Revised Major Final Site Plan MC Project No.: J040-011

We offer the following responses to comments dated June 13, 2018 regarding the Martin County Growth Management Department (MCGMD) staff's review of the Major Final Site Plan Application.

## ADVANTAGE SELF STORAGE JENSEN BEACH Revised Major Final Site Plan

SITE PLAN

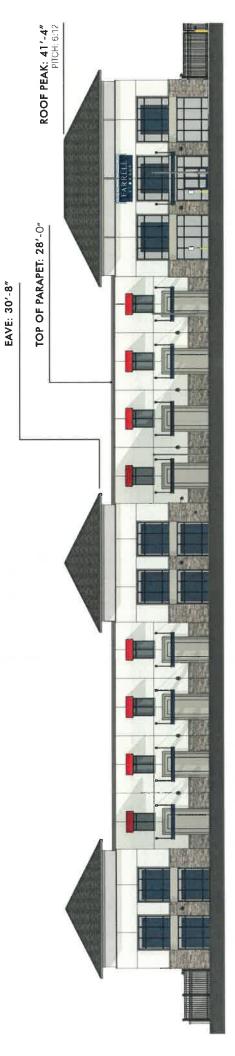
1. Please remove the 'greyed out' survey line-work from the site plan for legibility. The revised final site plan should have only those elements shown and labeled that are required to demonstrate compliance with the Land Development Regulations regarding site design.

2. Please add "Minimum" or "Min" to each labeled finished floor elevation on the site plan.

- 3. Please show and label the following on all adjacent properties, including any delineating limits for adjacent uses or districts that differ along one boundary (e.g. existing commercial and residential uses along eastern property line):
  - a. Existing Use
  - b. Future Land Use Designation
  - c. Zoning District

4. Please annotate the boundary of the property on the revised final site plan, consistent with the submitted boundary survey.

5. Please clarify the limits of required landscape buffers. Staff cannot distinguish between the proposed landscape buffers that are required by code and pervious areas adjacent to existing commercial and residential development that are not proposed to meet the requirements of a landscape buffer on the site plan. Staff recommends that required buffers be shown distinctly separate from other pervious areas.

6. Please revise the legend to include only those items that are shown on the site plan (e.g. truncated dome mats are in the legend but not shown on the site plan).

7. Please dimension all buildings and show entrances.

9. Please add setback data to the Building Data table to include the minimum required and the provided setbacks from buildings to the nearest front, side and rear property lines to demonstrate compliance with the zoning standards for COR-1.

Show on the Site Plan the required Patio / Pedestrian Arcade adjacent to the customer entrance.

Show on the site plan the required structural or vegetative shading along the front walkway.

Show on the Site Plan the required two bike racks and two benches.

MEP: Acknowledged. Please see revised site plan, sheet SP-1.

MEP: Acknowledged. Please see revised site plan, sheet SP-1.

MEP: Acknowledged. Please see revised labels of all adjacent properties on sheet SP-1.

MEP: Acknowledged. Please see revised site plan, sheet SP-1.

MEP: Acknowledged. Please see revised site plan, sheet SP-1.

MEP: Acknowledged. Please see revised site plan, sheet SP-1.

MEP: Acknowledged. Please see revised site plan, sheet SP-1.

MEP: Acknowledged. Please see revised site plan, sheet SP-1.

MEP RESPONSE: Acknowledged. Please see revised site plan, sheet SP-1.

MEP RESPONSE: Acknowledged. Please see revised site plan, sheet SP-1.

MEP RESPONSE: Acknowledged. Please see revised site plan, sheet SP-1.

### BUILDING 1 SOUTH ELEVATION

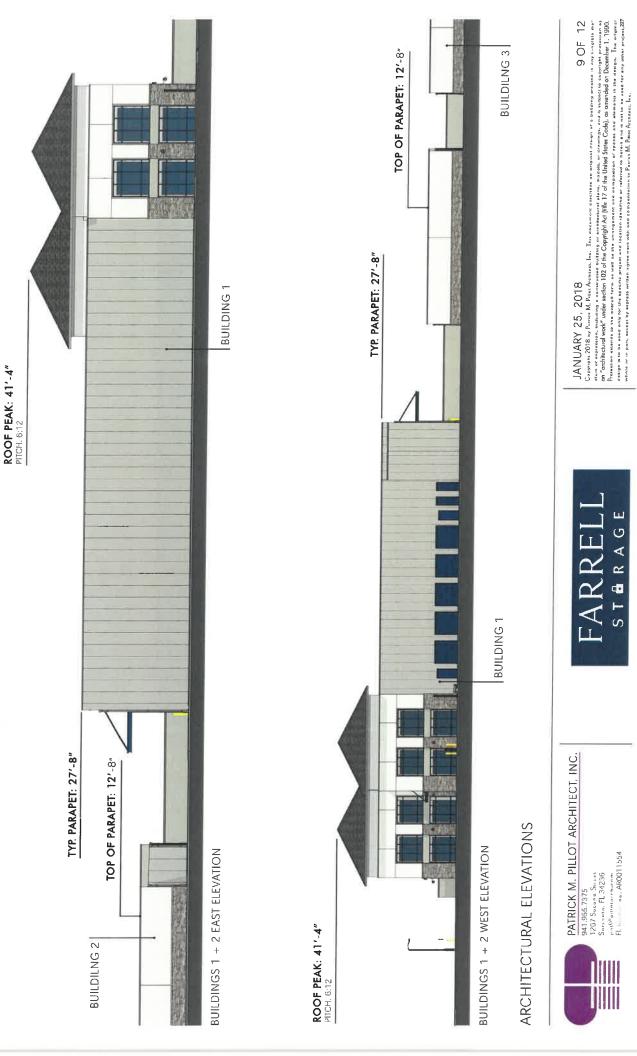
Pursuant to Section 3.12., LDR, Martin County, Fla. (2005), the maximum allowable building height in the COR-1 zoning district is 30 feet. The submitted elevations show structures exceeding 40 feet in height and do not show the dimensions of the elements required for the methodology of determining height pursuant to Section 3.14., LDR, Martin County, Fla. (2005).

Please submit revised architectural elevations that show both vertical and horizontal dimensions as required by the codified methodology to demonstrate compliance.

Staff is unable to verify that the current project design meets this requirement for residential storage buildings located within the COR land use. Please submit revised architectural elevations and renderings and explain how the building design meets the requirements of Policy 4.13A.8.(1)(a), CGMP, Martin County, Fla. (2018) and Section 3.94.B., LDR, Martin County, Fla. (2002).

The primary façade appears to have a stucco finish and a split face stone finish. The main building secondary facades appear to have a metal siding finish that is not consistent with the primary façade. Please provide the elevation drawings of the Buildings B and C in order to verify compliance with this section.

Provide a parapet of at least one foot in height along any primary façade and shall have at least two changes in height of a minimum of two feet. Label on the elevation drawings the height of the proposed parapet on all the flat roof of the primary façade. Provide a detail of the required three-dimensional cornice treatment with a minimum of three reliefs.

Show on the elevation drawings the location and dimensions of any roof mounted mechanical equipment.

PMPA RESPONSE: The Applicant has reduced the height of the two-story building (Building C) to reflect a maximum height of 30'-0" to the midpoint of the pitched roofs on the tower features. Additionally, the Applicant has provided both horizontal and vertical dimensions on the building elevations on the revised architectural plans provided with this submittal.

PMPA RESPONSE: The Applicant has coordinated with staff regarding the requested changes to comply with the above-referenced sections. To that end, the Applicant has revised the rear/south elevation of the southernmost one-story building (Building A) to reduce the number of overhead doors and to create three sections of elevations that contain architectural enhancements that include stucco, raised parapets, siding and applied windows. Said enhancements are intended to provide architectural interest to the rear elevation of Building A and to mimic the architectural style of and blend harmoniously with residential structures. The Applicant has also provided substantial enhancements the side elevations of the one story buildings, which could be seen from adjacent properties that contain multiple stories, to include raised parapets, applied windows, siding and brick cladding to reflect a residential style. Additionally, the Applicant has reduced the overall lengths of the one story buildings so that foundation landscaping could be provided on the sides of the one-story buildings that face residential. It should be noted that a six (6) foot opaque privacy fence will surround the west, south and east sides of the property to provide further screening from adjacent properties.

PMPA RESPONSE: The secondary facades of the primary building (Building C) have been upgraded substantially to include the same materials, finishes and colors found on the primary façade and to include windows and awnings to add architectural interest and replicate the architectural style of the primary façade.

PMPA RESPONSE: The architectural elevations for Building C have been updated to demonstrate compliance with the above-referenced requirement. Additionally, a detail of the three-dimensional cornice treatment depicting a minimum of three reliefs is also provided.

PMPA RESPONSE: Acknowledged. Please see revised elevation drawings.
